SUBJECT: Transmittal of Westinghouse Responses to Open Items Identified in the AP1000 Draft Safety Evaluation Report

DCP/NRC1603
Docket 52-006

Westinghouse Non-Proprietary Response to
AP1000 Draft Safety Evaluation Report (DSER) Open Items

Figure 220.32-1 Comparison of Capacity Reduction Factors for Tests with Code Case N-284

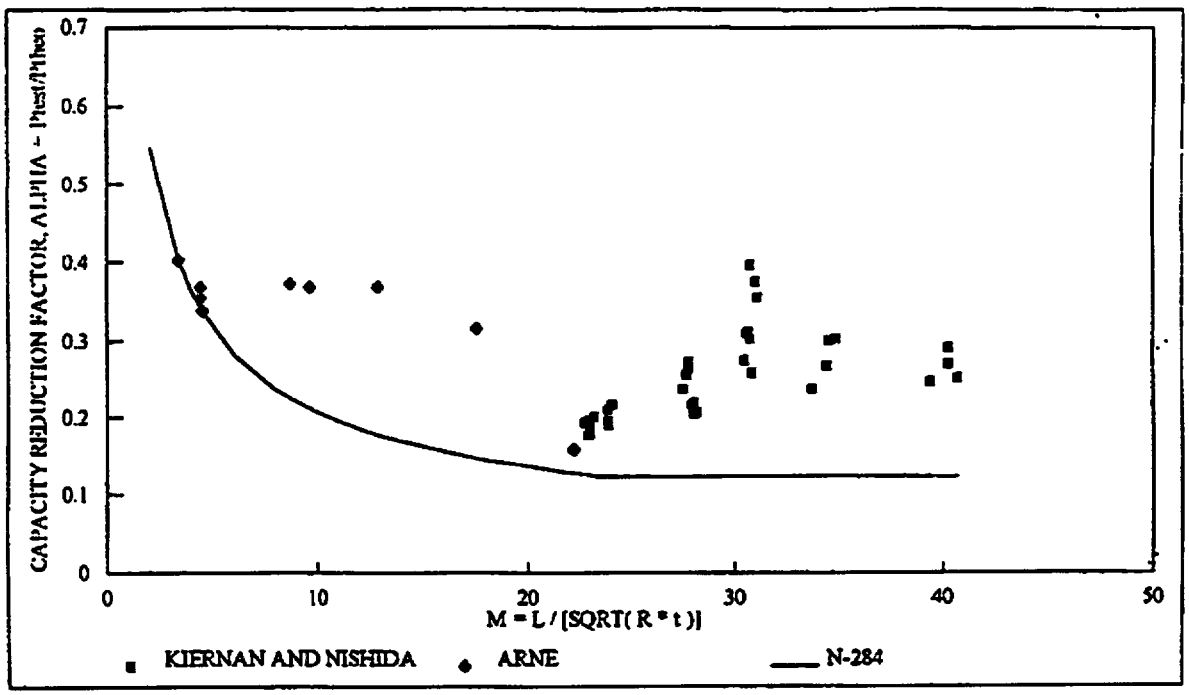
Westinghouse estimates critical buckling pressures for equipment hatches as 196 psig for a 22-foot-diameter hatch and 161 psig for a 16-foot-diameter hatch. The corresponding ASME Level C Service Limits are 117 psig and 96 psig using the Code Case N-284, respectively. From Figure 3.8.2-2, the equipment hatch covers appear convex to the center line of the containment. Therefore, the use of the Code Case N-284 (i.e., the factor of safety of 1.67 for the Level C Service Limit) is not acceptable because the internal pressure of the containment acts as the external pressure to the spherical cap covers and subjects the cap covers to compression. In the case of external pressure, ASME NE-3222 (i.e., the factor of safety of 2.5 for the Level C Service Limit) should be used for the compressive stresses. Note (1) in Table 3.8.2-2 should be revised to reflect the factor of safety of 2.5, or acceptable justification should be provided for not doing so (Section 3.8.2 of the SSAR).

Code Case N-284 provides criteria for evaluation of unstiffened spherical caps subjected to compressive stress due to pressure loading. In the Code Case, the theoretical buckling value is given in paragraph 1712.1.3, the capacity reduction factor is given in paragraph 1512 (b), and the plasticity reduction factor is given in paragraph 1620 and 1610 (a). The capacities of the hatch covers as described in the SSAR are in accordance with this code case.

ASME Code Case N-284 was developed by the code committee based on detailed review and evaluation of test data. Figure 220.32-1 shows test results from references 220.32-1 and 220.32-2 for fabricated steel hemispherical shells and spherical segments. The ratio of test buckling stress to theoretical buckling stress (α) is shown as a function of the non-dimensional unsupported length along the shell ($M = L_i/\sqrt{Rt}$, where L_i is the unsupported length along the spherical shell, R is the radius of the shell and t is the thickness of the shell). The lower bound curve to these data points, as shown in the figure, is used in Code Case N-284. For the AP600 16 foot diameter equipment hatch, $M = 14.5$, and the capacity reduction factor, corresponding to α in the figure, is 0.167. The stresses in the hatch cover are well below yield and the plasticity reduction factor is unity. The test data for shell lengths of 10 to 20 show capacities significantly above those of the Code Case. The capacity of the hatch covers, as calculated by the ASME Code Case, corresponds to the lower bound of the test data. As a result the 1.67 factor of safety specified in paragraph 1400 of the ASME Code Case is considered appropriate for calculating the Service Level C pressure capacities of the hatch covers.
